Montgomery County Historic Preservation

Staff Report

<p>ADDRESS: 3710 Bradley Lane, Chevy Chase</p> <p>RESOURCE: Chevy Chase Village Historic District</p> <p>APPLICANT: Robyn Segal, Lapp & Associates (Architect)</p> <p>REVIEW: HAWP</p> <p>CASE NO.: 1153039</p> <p>PROPOSAL: Partial Demolition and Alterations to the Existing House, Construction of a new Dormer, Additions, and Porches; Alterations to the Garage, and Tree Removals</p>	<p>MEETING DATE: 6/10/2026</p> <p>REPORT DATE: 6/3/2026</p> <p>PUBLIC NOTICE: 5/27/2026</p> <p>TAX CREDIT ELIGIBLE: No</p> <p>STAFF: Dan Bruechert</p>
---------------------------------------------------------------------------------------------------------------------------------------------------------------------------------------------------------------------------------------------------------------------------------------------------------------------------------------------------------------------------------------------------------------------------------------------	--------------------------------------------------------------------------------------------------------------------------------------------------------------------------------------

Figure 4: Existing right elevation (left) and proposed (right).

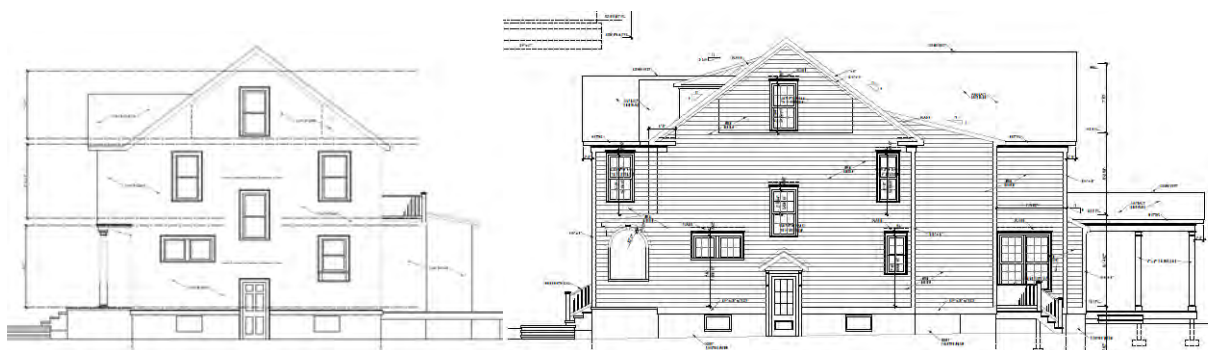
On the west (right) elevation, the applicant proposes to relocate one window in the existing portion of the house and to narrow the two rear-most window openings. At the rear of the right elevation, the applicant modified the design by adding a second window to create a paired window opening on the first floor.

Under the very lenient level of review dictated by the *Design Guidelines*, Staff find the proposed materials are consistent with what the HPC has approved for new construction throughout the Chevy Chase Village Historic District. Staff additionally finds the design changes are compatible with the house's Colonial Revival architecture. Staff felt compelled to bring this proposal before the HPC as a Preliminary Consultation to solicit feedback from the Commissioners on the appropriateness of the size and massing. Based on the information presented at the Preliminary Consultation, Commissioners suspected that the design would not overwhelm the streetscape but requested a little more information to help with its evaluation. The applicant developed a streetscape study and supplied additional contextual photos that show while the proposed house and addition are large, Staff does not find they overwhelm the neighboring houses and are detrimental to the historic character of the district as a whole. Staff recommends the HPC approve the house additions and alterations under 24A-8(b)(2) and (d) and the *Design Guidelines*.

Figure 6: Proposed garage modifications with the existing roofline dashed.

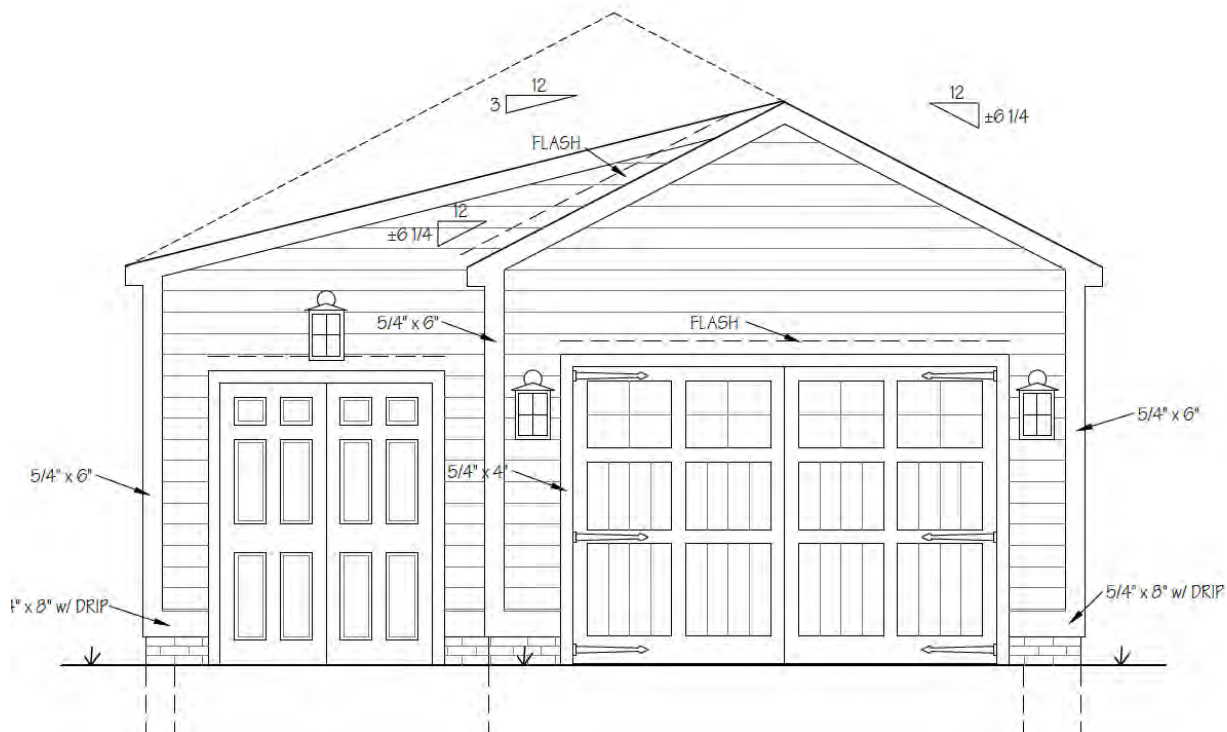
In the southeast corner of the subject property, there is a painted brick, two-car garage with a metal roll-up door. The Master Plan Amendment establishing the historic district categorizes the garage as Non-Contributing. Approximately 8' (eight feet) of the garage will be demolished, leaving a one-bay garage and a small shed-roofed storage area. The roof of the garage will be reconstructed, lowering the ridge height by approximately 3' (three feet). Additional changes include installing new siding and trim to match the house, a pair of doors to the storage area, new carriage style garage doors, and a half-lite door and six-over-six window. The new siding will leave a small overhang exposing a portion of the existing brick siding. Architectural roof shingles and half-round gutters will also match the materials proposed for the house.

As a Non-Contributing Resource, the *Design Guidelines* allow for extensive alterations up to and including demolition. Based on the guidance provided in the *Design Guidelines*, most alterations to Non-Contributing garages should be approved as a matter of course. Nevertheless, Staff finds the proposed changes to the garage are in keeping with the character of the site and surrounding historic district. Commissioners supported these alterations at the Preliminary Consultation and Staff recommends the HPC approve the garage alterations under 24A-8(b)(2) and (d) and the *Design Guidelines*.
